**Town of Kittery
Planning Board Meeting
June 8, 2023**

ITEM 1 – Green Truck Farm/ 89 Route 236 Site Plan Modification and New Marijuana Business Review

**RE: Major Modification to an Approved Site Plan Application – Preliminary Revisions
Green Truck Farm (Tax Map 28, Lot 14-2)
89 Route 236, Kittery, Maine**

GRADING & UTILITIES PLAN
GREEN TRUCK CANNABIS DISPENSARY
89 ROUTE 236, KITTERY, MAINE

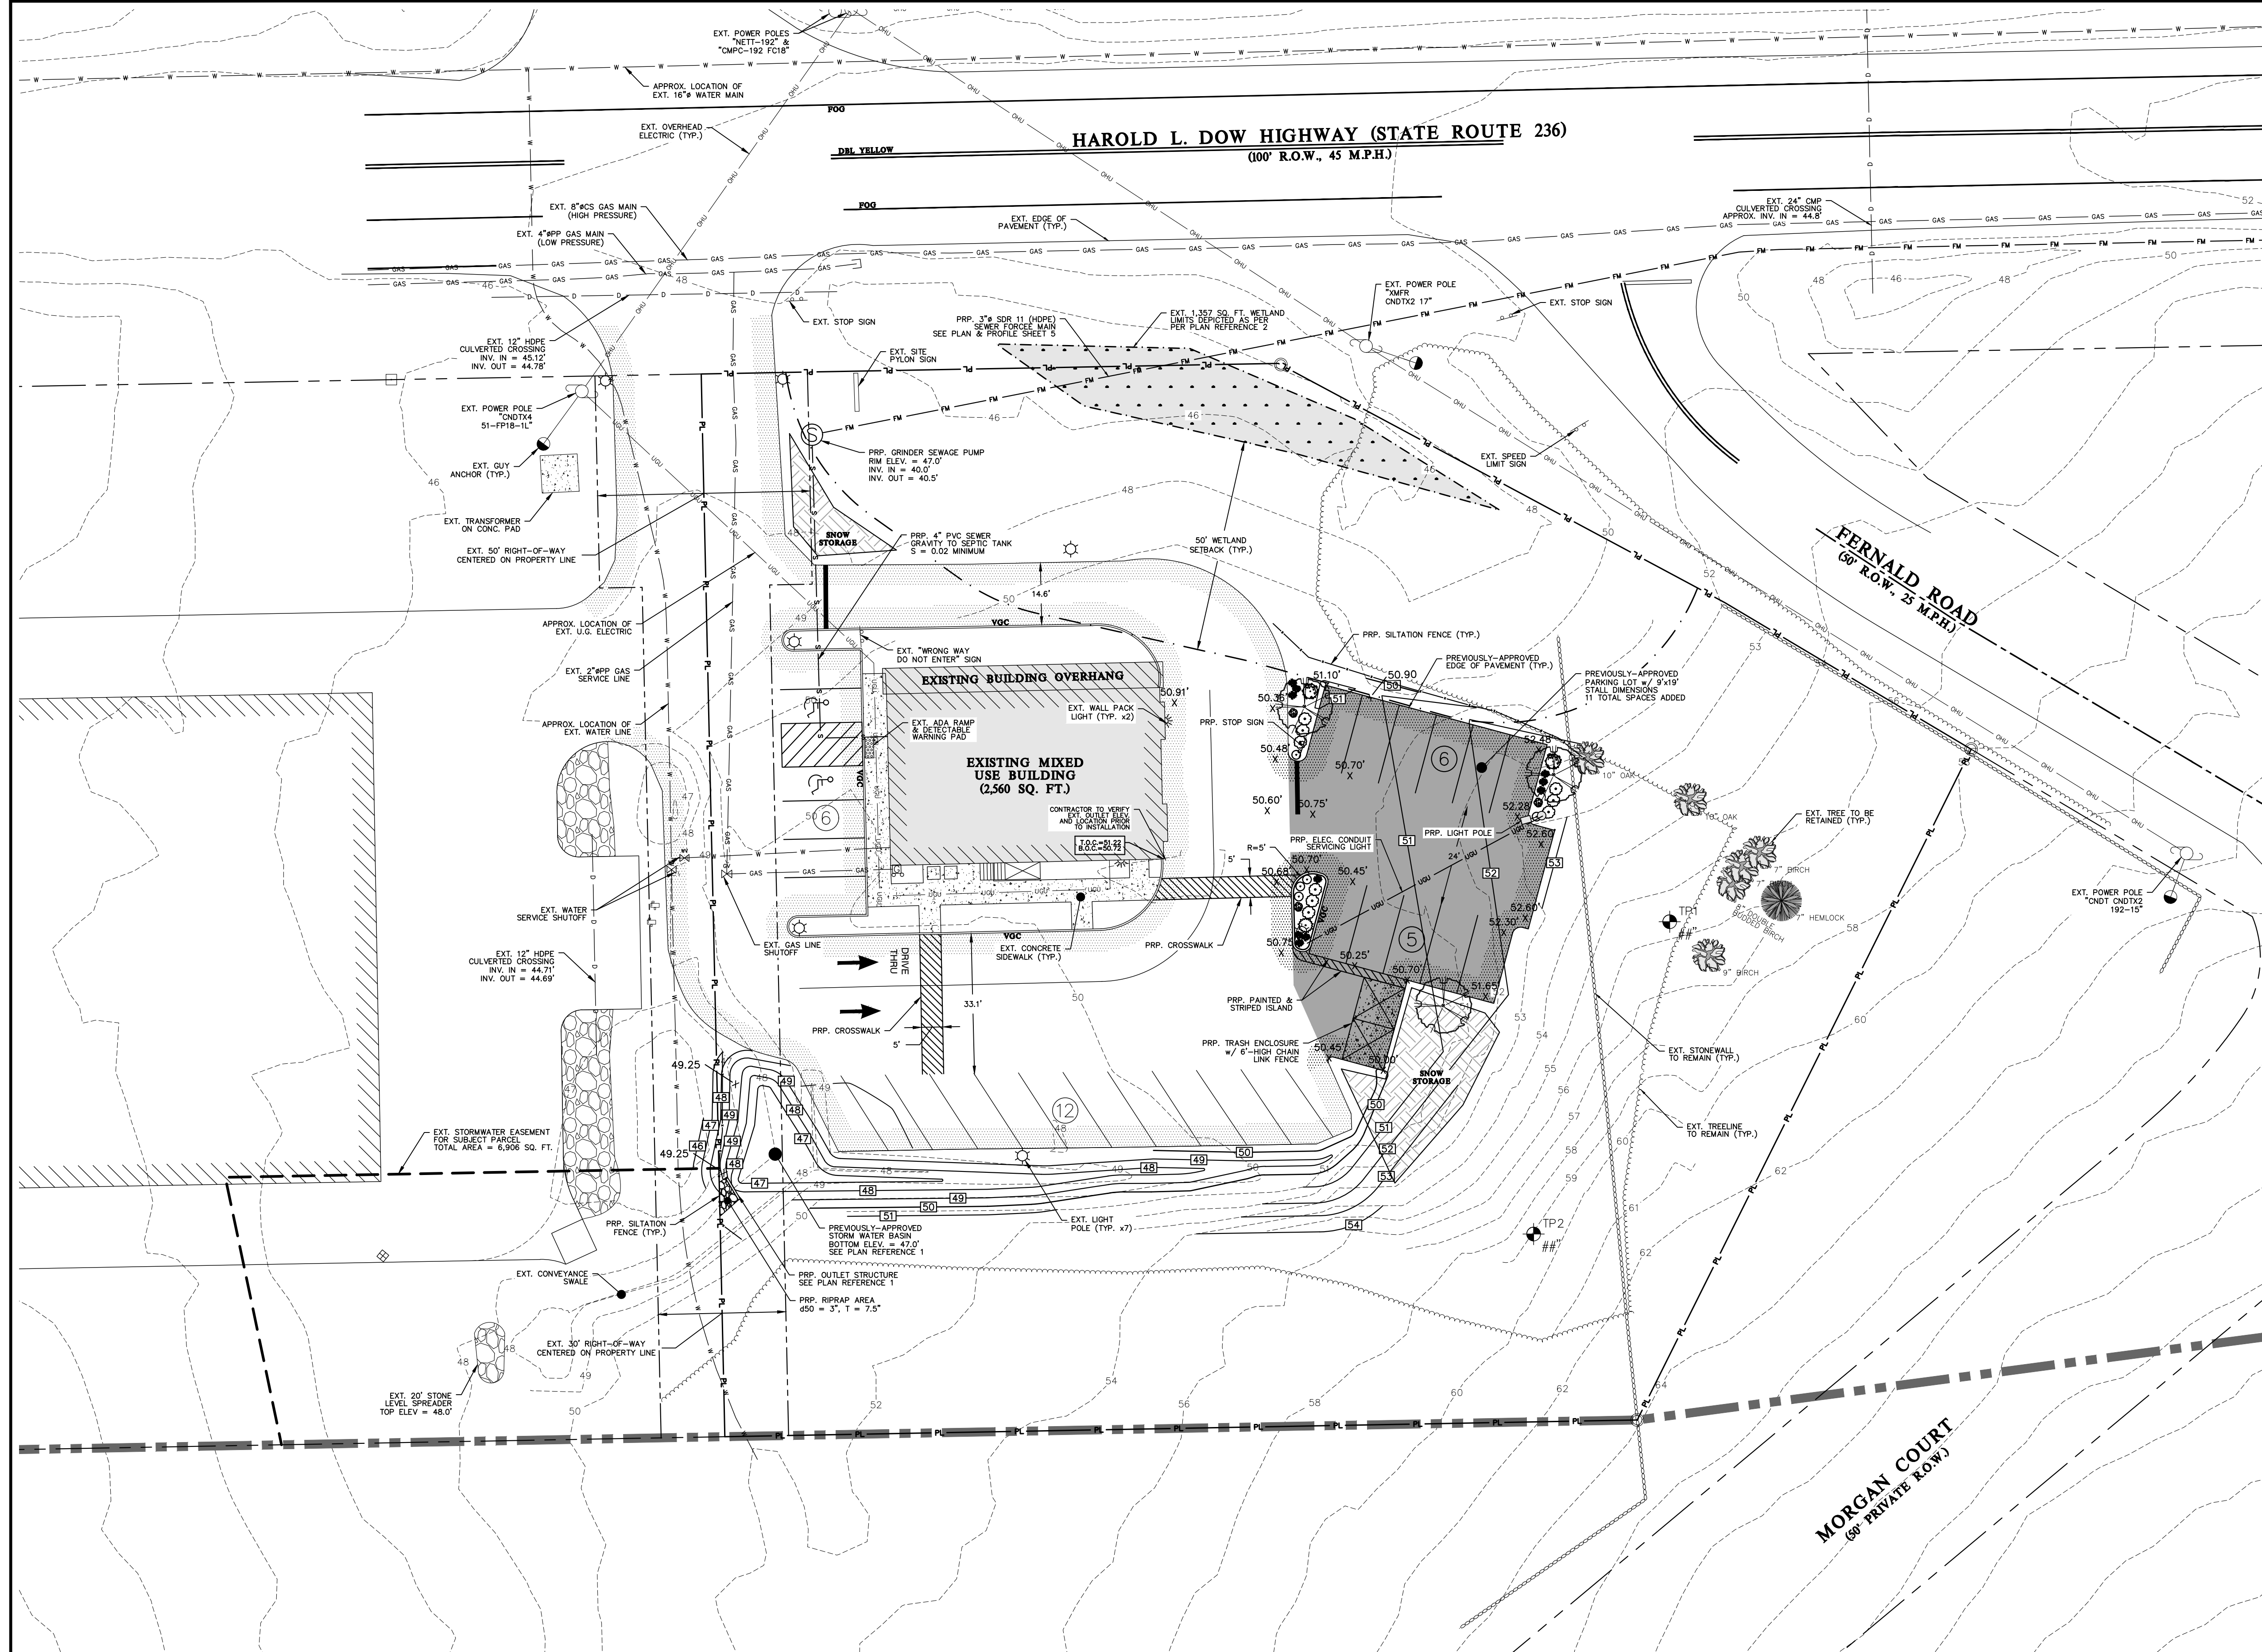
- Utility-locating services contracted by DigSafe visited the site on May 23rd and identified the location of the existing 8" gas main that has been approximately identified in the Plan Set. Not previously identified was the additional 4" gas main which extends from the northwest and terminates near the existing entrance to the mixed use building. The installed location of the 2" gas service line to the existing building was also identified. All identified underground utilities were survey-located by Attar Engineering on May 24th and have been added to the Plan Set. General Note #4 on Sheet 3 has also been added to summarize the above.

- In response to the updated existing utility locations, the Applicant is proposing a modification to the sewer force main that is to be extended southeasterly to tie into the municipal sewer system near the car wash. A directional drill shall be utilized for the first ~220 feet of the force main extension, which shall span from the grinder pump station to the southern edge of Fernald Road, notably going beneath and avoiding the entirety of the existing on-site wetland. This change will avoid any potential impacts to the wetland that could be incurred by construction trenching activity in the Route 236 southbound shoulder and swale.

Plan Name: **GRADING AND DRAINAGE PLAN**

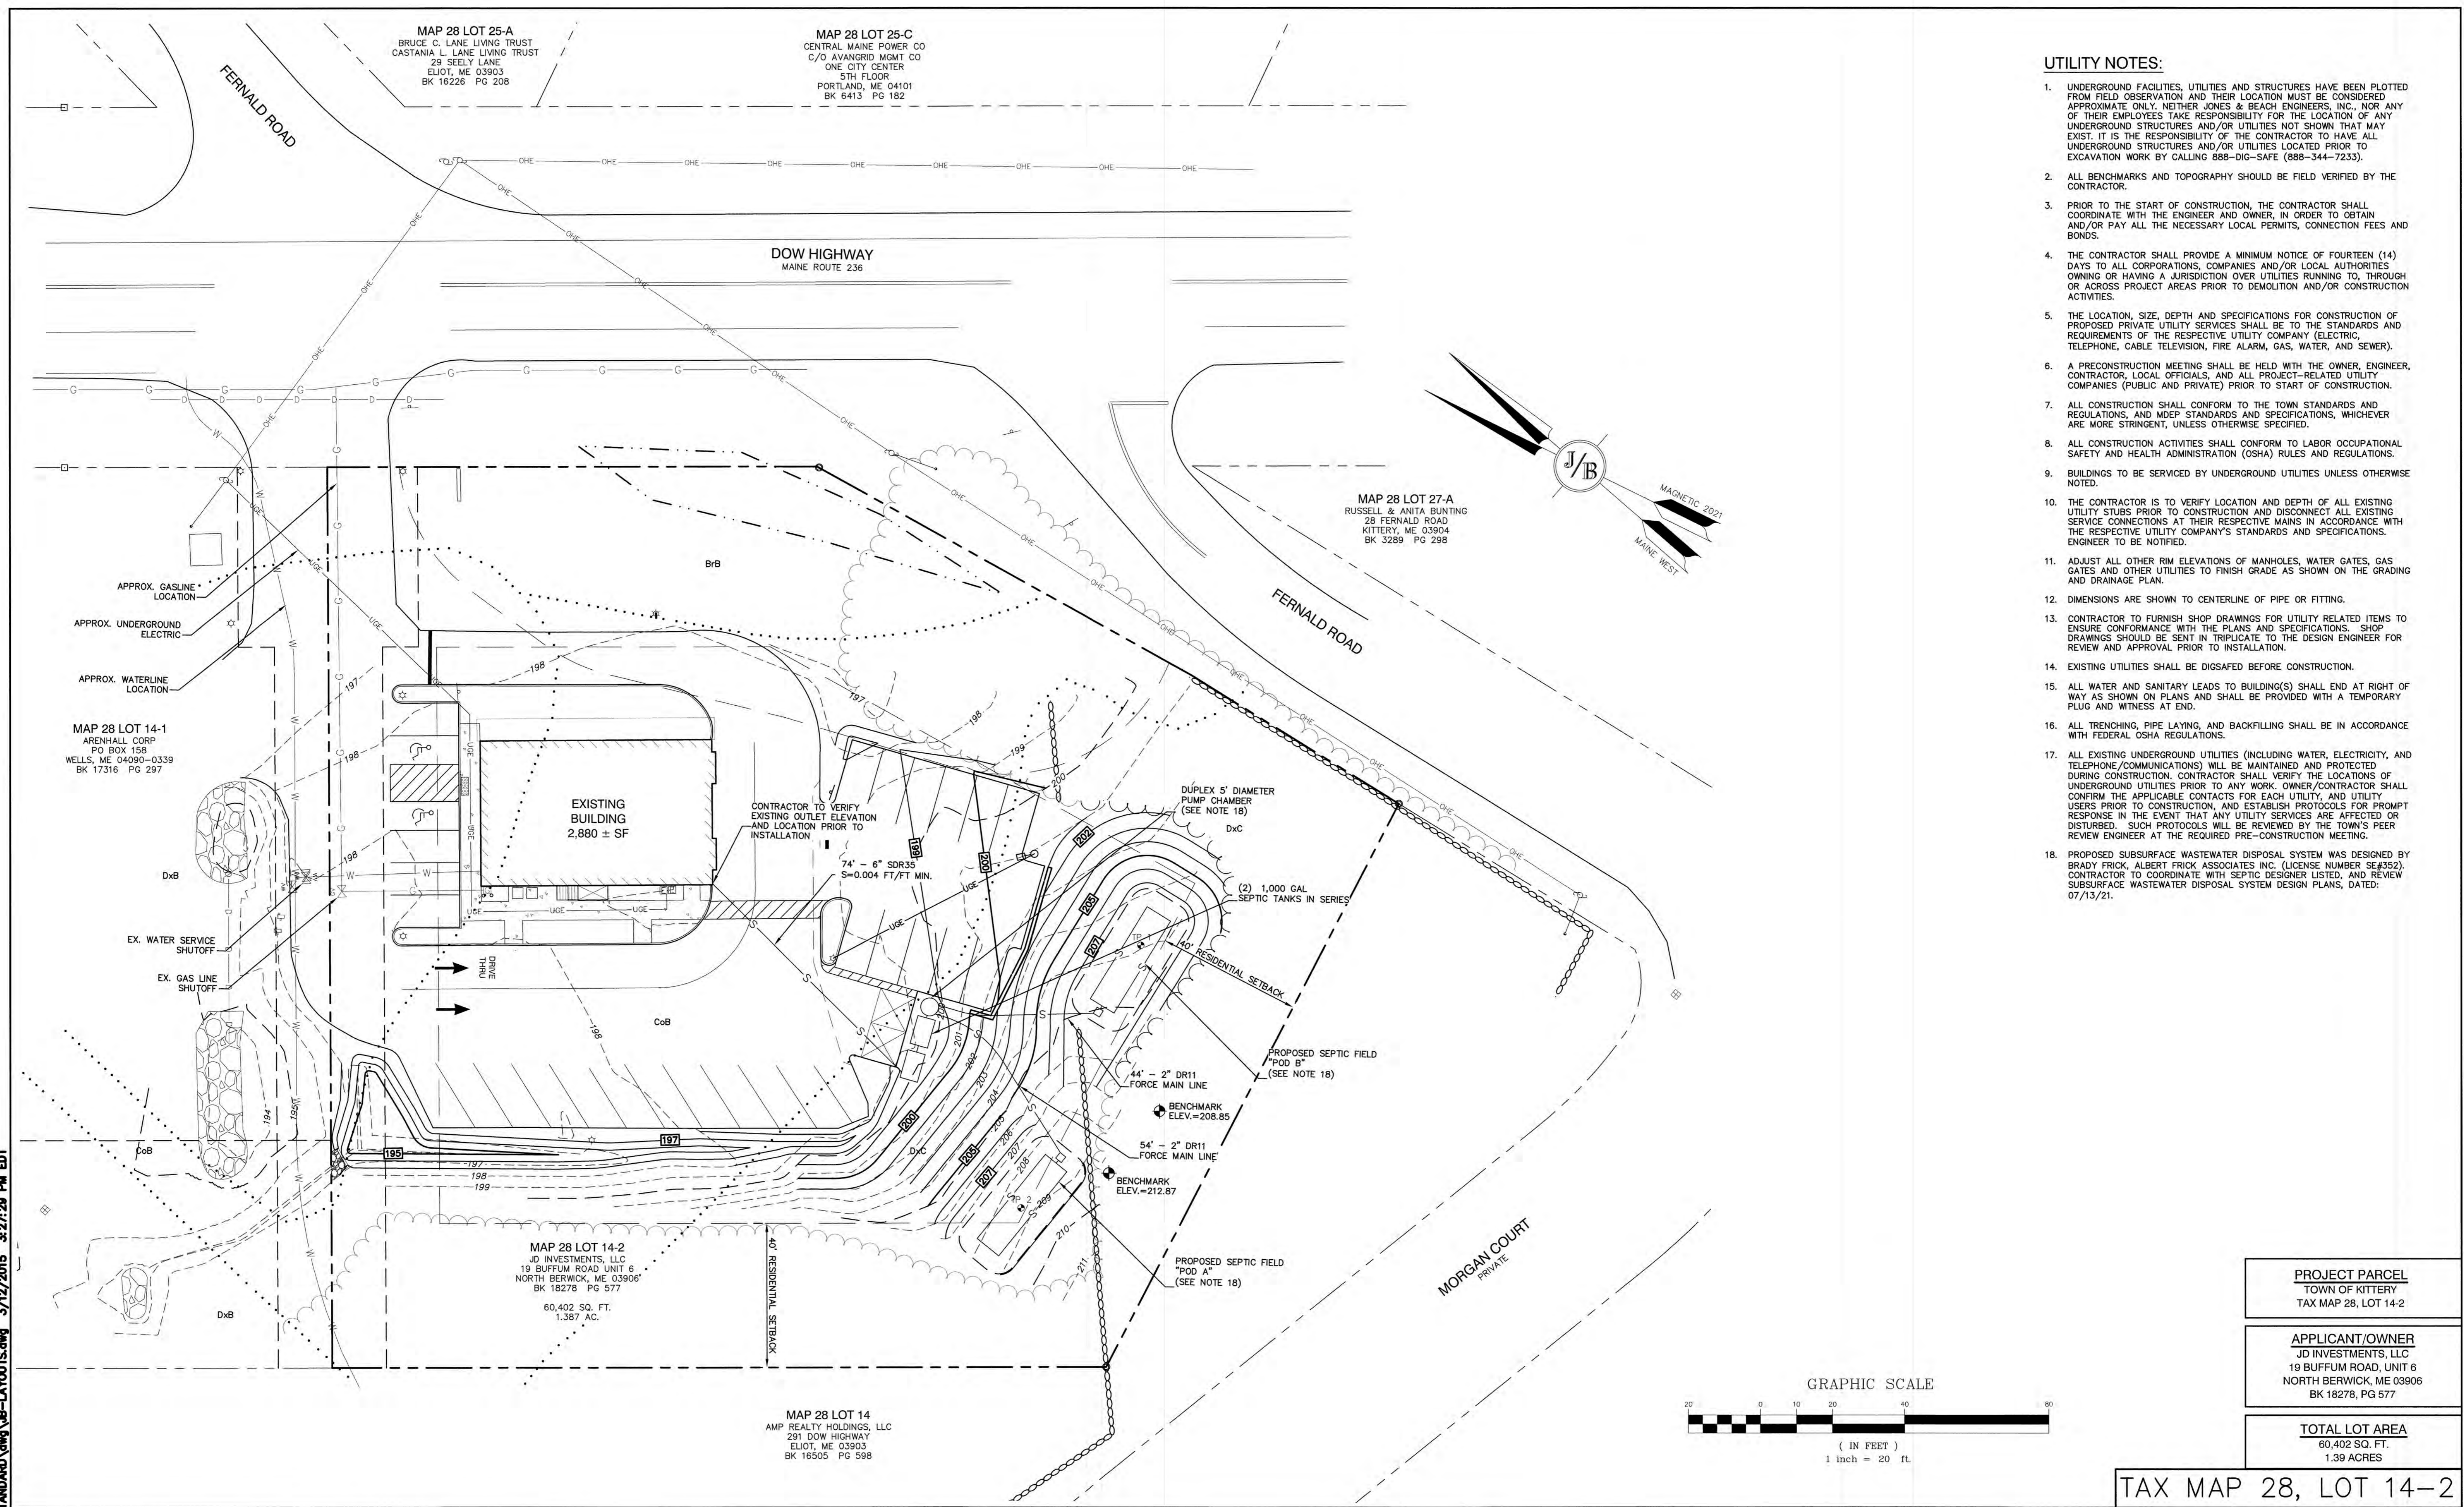
2. *The applicant should provide details for the stormwater basin and outlet structure. Leaders on Sheet C3 reference detail Sheet D1, but this was not included in the plan set.*

The applicant should provide details for the stormwater basin and outlet structure. Leaders on Sheet C3 reference detail sheet D1, but this was not included in the plan set.

RESPONSE: The details in question are included on Sheet D1. This Sheet has been included in the updated plan set included with this letter.
3. *Following the site walk the Town of Kittery requested additional information with respect to the classification of existing pond on site. Gove Environmental Services, Inc. provided a response letter and characterization of the stormwater feature as a detention pond and not a wetland. Their assessment includes discussion of a DEP Stormwater/Site Law permit for maintenance requirements. Does the applicant have this permit? A copy should be submitted to the Town for the project record.*
